CITY OF ALBUQUERQUE

Re: Toyota Temporary Parking Lot, Grading and Drainage Plan
Certification dated –no date–
Engineer's Stamp Date 4-13-15 (C18D083)

Weighted E Method
AMERICAN TOYOTA TEMPORARY YARD

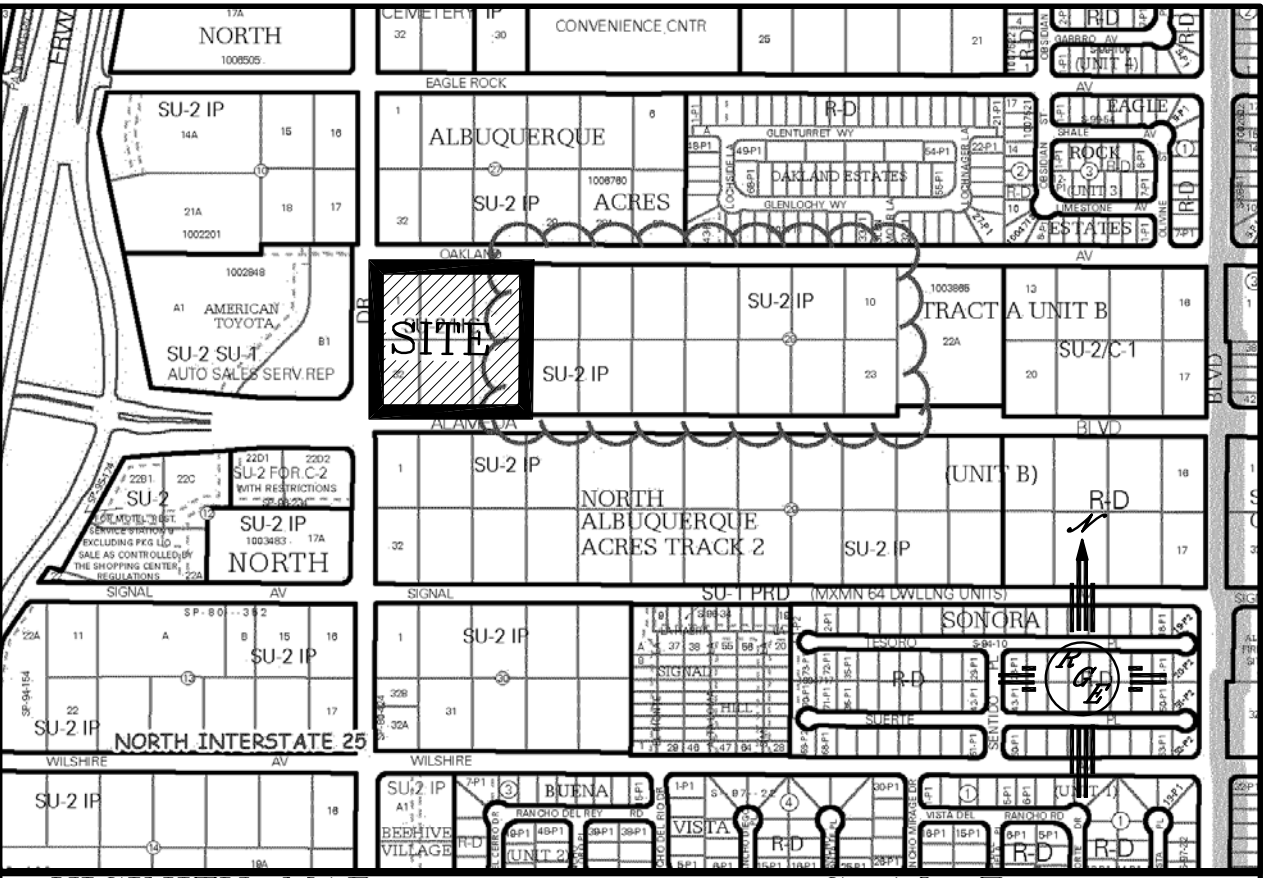
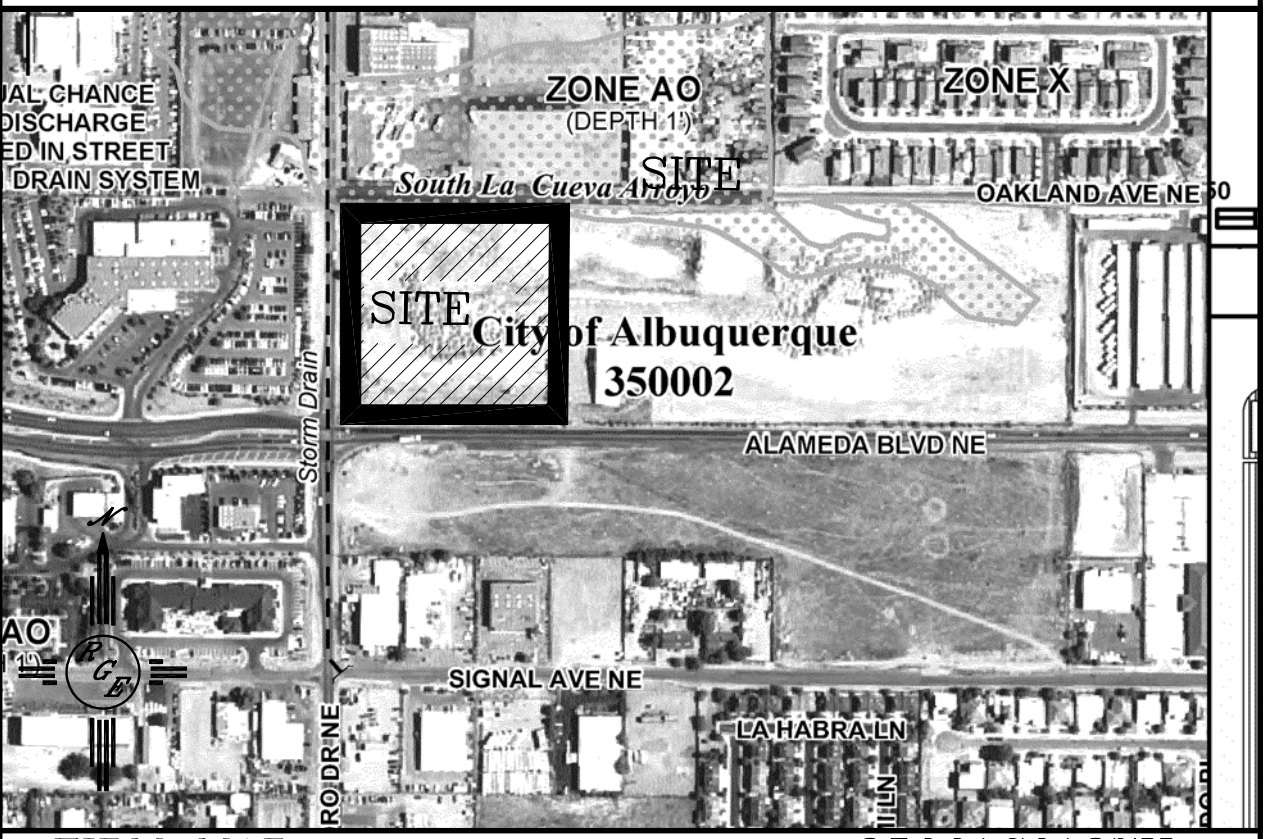
This certification was not dated, the approved plan date in the certification language is incorrect (5-16-13 vs. 4-13-15) and the status of the Work Order was not provided as stated in the approval letter dated 4-21-15. The City does not wish to hold up progress on the Toyota site across the street due to administrative errors and the project manager explained the progress of the Work Order on 6-2-15 to the City's satisfaction.

inlets to be constructed with work order, not yet approved

1. RIP RAP AND APRONS AT PONDS WILL BE CONSTRUCTED WITH INLETS TO ALLOW FOR SMOOTH TRANSITION.
2. INLETS CAN NOT BE CONSTRUCTED UNTIL WORK ORDER IS APPROVED
3. ASPHALT CURB NOT CONSTRUCTED UNTIL INLETS THAT COLLECT THE WATER ARE CONSTRUCTED. THE CONCENTRATION OF FLOW AND CHANGE OF DIRECTION NOT RECOMMENDED UNTIL COLLECTION INLET IS BUILT.

Therefore, after the drainage work in the City ROW and the site work that was not completed are complete; submit an engineer's certification on the plan dated 4-13-15. Acceptance of the certification is required prior to obtaining Certificate of Occupancy on the Toyota building across the street.
